MEMPHIS AND SHELBY COUNTY OFFICE OF PLANNING AND DEVELOPMENT

STAFF REPORT #12

CASE NUMBER: PD 11-308 **L.U.C.B. MEETING:** June 9, 2011

DEVELOPMENT NAME: The Stone Institue Planned Development

Site Plan

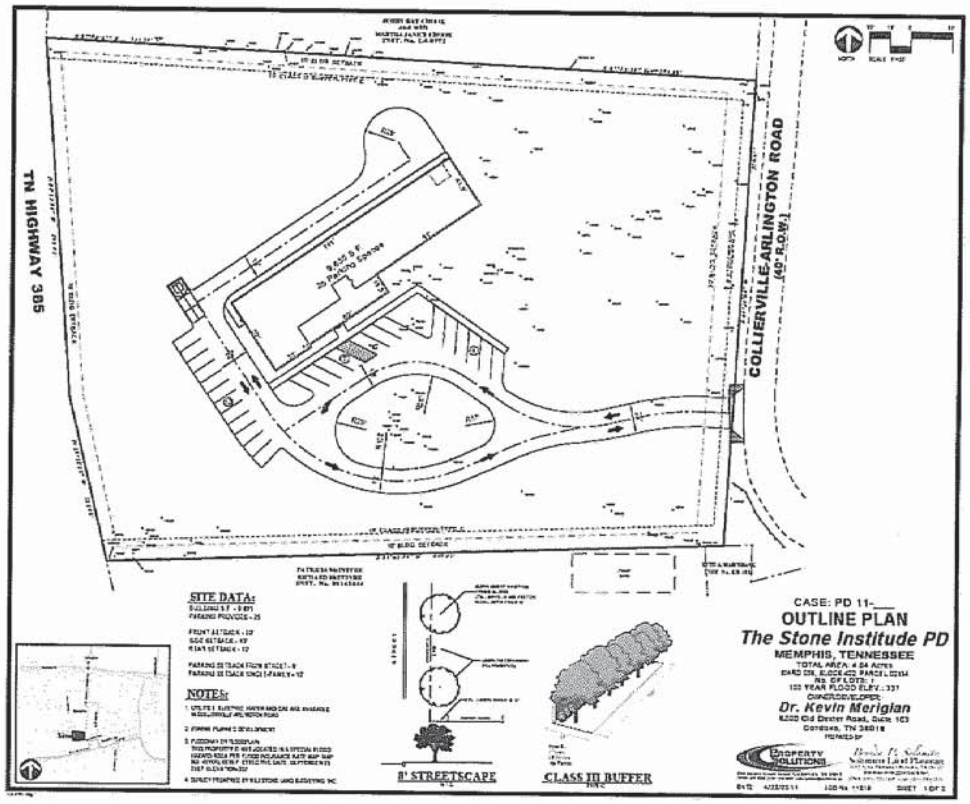
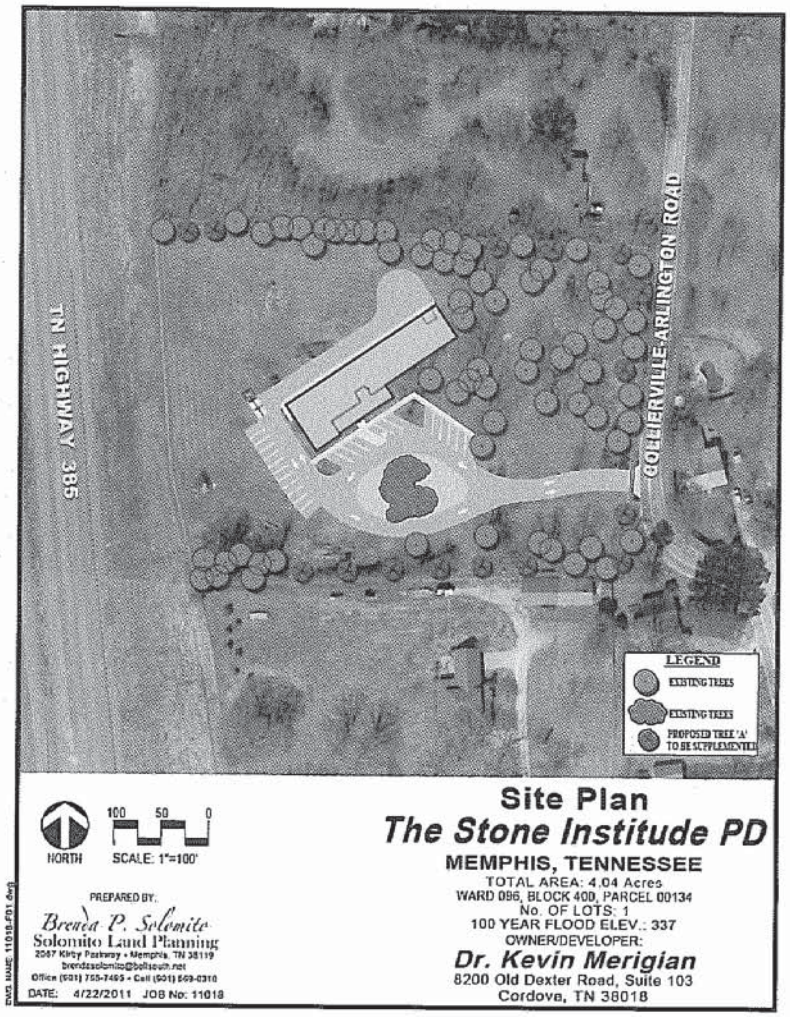
Some changes to the site plan are needed. The most notably change is to the location of the entry drive. This driveway is located very close to the beginning of the S curve in Collierville-Arlington and needs to be relocated. Other changes include some revisions to the setbacks.

6. The sight distance from the proposed location of the driveway appears insufficient. The driveway shall be moved further north to a location where adequate sight distance is achieved.

7. The driveway connection shall be an asphalt driveway connection, rather than the standard urban curb cut shown on the plan.

This plan is being reviewed as a one phase site plan to allow the building and parking as shown on the Outline Plan/Site Plan. While the conditions allow for multiple buildings on the lot, this plan does not illustrate that concept. Changes to the Site Plan and Conditions will require the filing of an application. The type of application and the required notice are subject to the discretion of the Planning Director.
